ADDENDUM NO. 1

**RE: City of Dublin
Dublin Community Recreation Center
Geothermal Project
Dublin, Ohio
PEA-13390**

Date: December 18, 2014

SITE
ELECTRICAL PLAN
SCALE: 1"=30'-0"

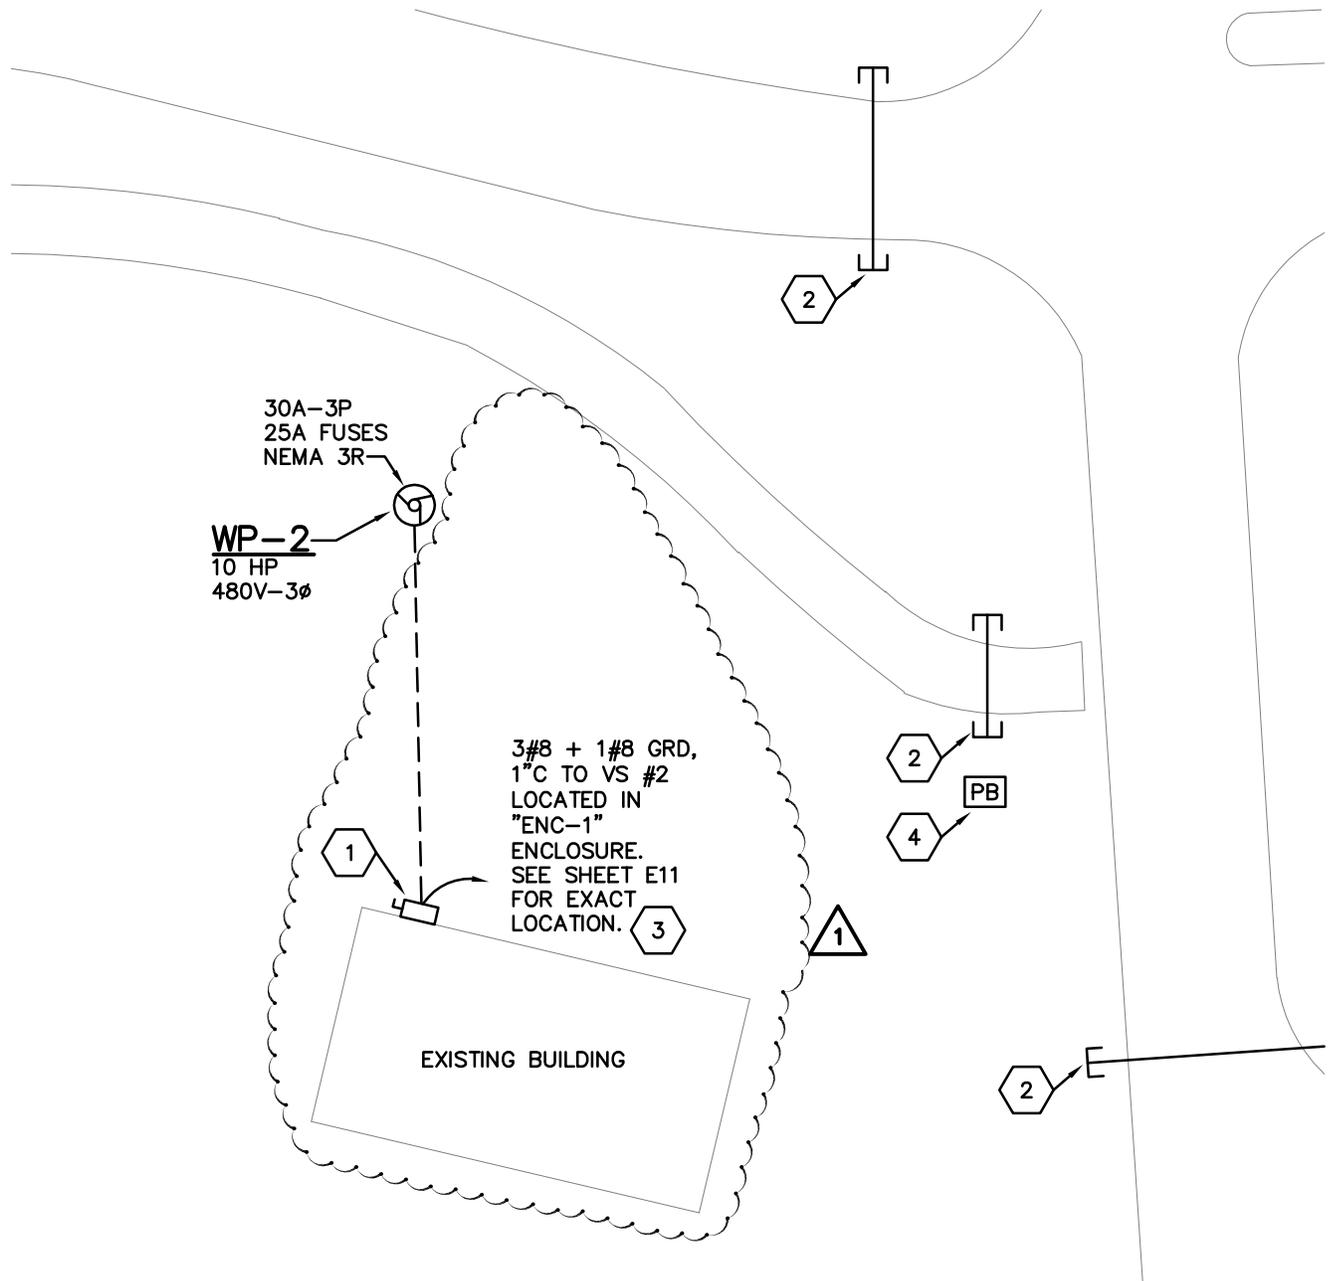
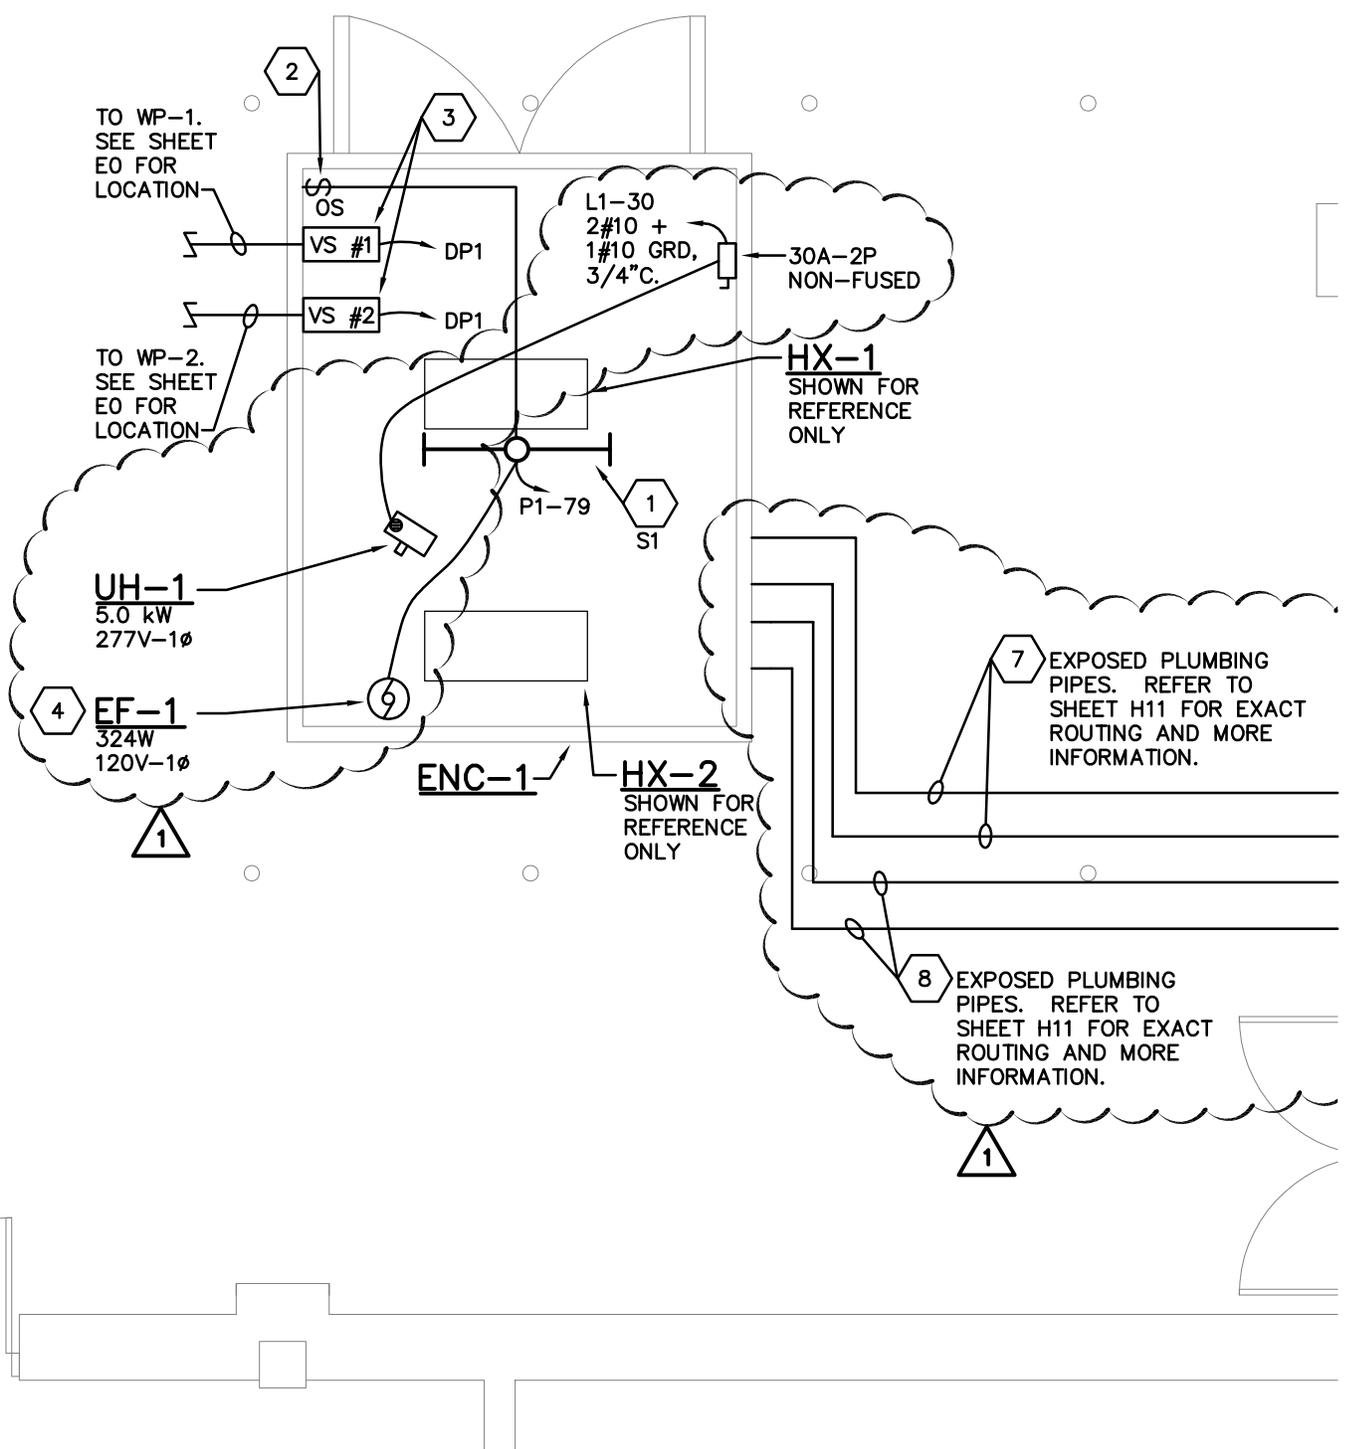
- A. For well pump WP-1, relocate the local disconnect switch and mount to the adjacent existing adjacent fence post, to the east of the WP-1 location. Final location to be approved by the City.
- B. For well pump WP-2, relocate the local disconnect switch and mount on the existing building to the west of the WP-2 location. Final location to be approved by the City.

PARTIAL COURTYARD
ELECTRICAL PLAN
SCALE: 1/4" = 1'-0"

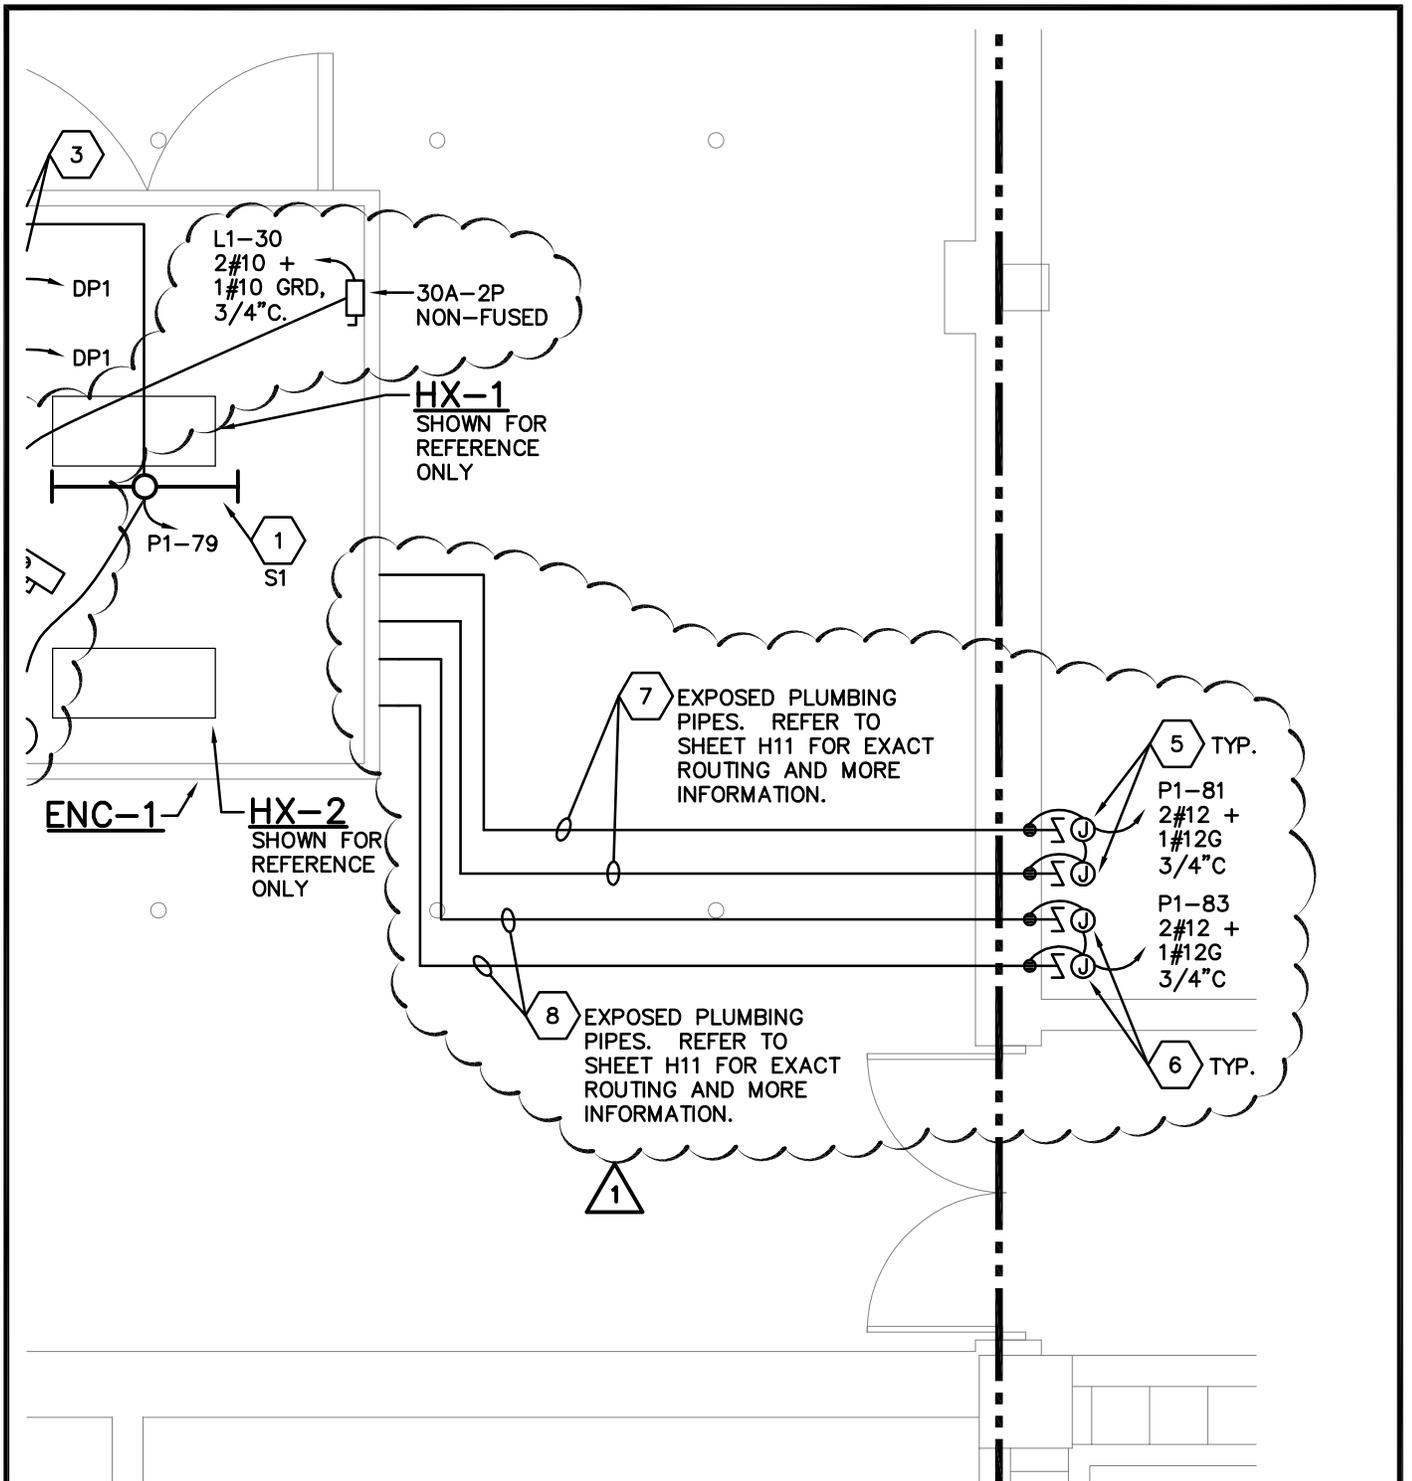
- A. At ENC-1, heat exchanger enclosure: For UH-1, revise the voltage and electrical circuit. Relocate the disconnect switch. Add power wiring for EF-1. Add heat trace cables and associated power wiring.
- B. Add coded notes 4 to 8.
- C. Add existing panel schedule L1.

4. MAKE CONNECTION TO FACTORY MOUNTED DISCONNECT SWITCH. ON-OFF CONTROL IS BY OTHERS. CONNECT TO THE LIGHTING HOME-RUN CIRCUIT AHEAD OF THE LIGHT SWITCH.

5. UNDER BASE BID, PROVIDE 120V CONNECTION TO HEAT TRACE CABLING. CONNECTION WILL BE PROTECTED BY A NEW GFCI CIRCUIT BREAKER LOCATED IN EXISTING PANEL P1.

6. UNDER ALTERNATE NO. 2, PROVIDE 120V CONNECTION TO HEAT TRACE CABLING. CONNECTION WILL BE PROTECTED BY A NEW GFCI CIRCUIT BREAKER LOCATED IN EXISTING PANEL P1.

7. UNDER BASE BID, EC SHALL FURNISH AND INSTALL HEAT TRACE CABLING ON THE PIPING SHOWN. BASIS OF DESIGN IS RAYCHEM XL-TRACE SELF REGULATING SERIES, #8XL1-CR SERIES @ 120V. INCLUDE RAYCLIC-PC POWER CONNECTION KIT, GLASS TAPE, AND #EC-TS AMBIENT THERMOSTAT. CONTACT FOR RAYCHEM IS DANNY RETO @ RELCON, INC. (614) 205-3115. COORDINATE WITH MR. RETO FOR ALL REQUIRED EQUIPMENT AND INSTALLATION INSTRUCTIONS.

8. UNDER ALTERNATE NO. 2, EC SHALL FURNISH AND INSTALL HEAT TRACE CABLING ON THE PIPING SHOWN. BASIS OF DESIGN IS RAYCHEM XL-TRACE SELF REGULATING SERIES, #8XL1-CR SERIES @ 120V. INCLUDE RAYCLIC-PC POWER CONNECTION KIT, AND GLASS TAPE. UTILIZE THE BASE BID #EC-TS AMBIENT THERMOSTAT. CONTACT FOR RAYCHEM IS DANNY RETO @ RELCON, INC. (614) 205-3115. COORDINATE WITH MR. RETO FOR ALL REQUIRED EQUIPMENT AND INSTALLATION INSTRUCTIONS.
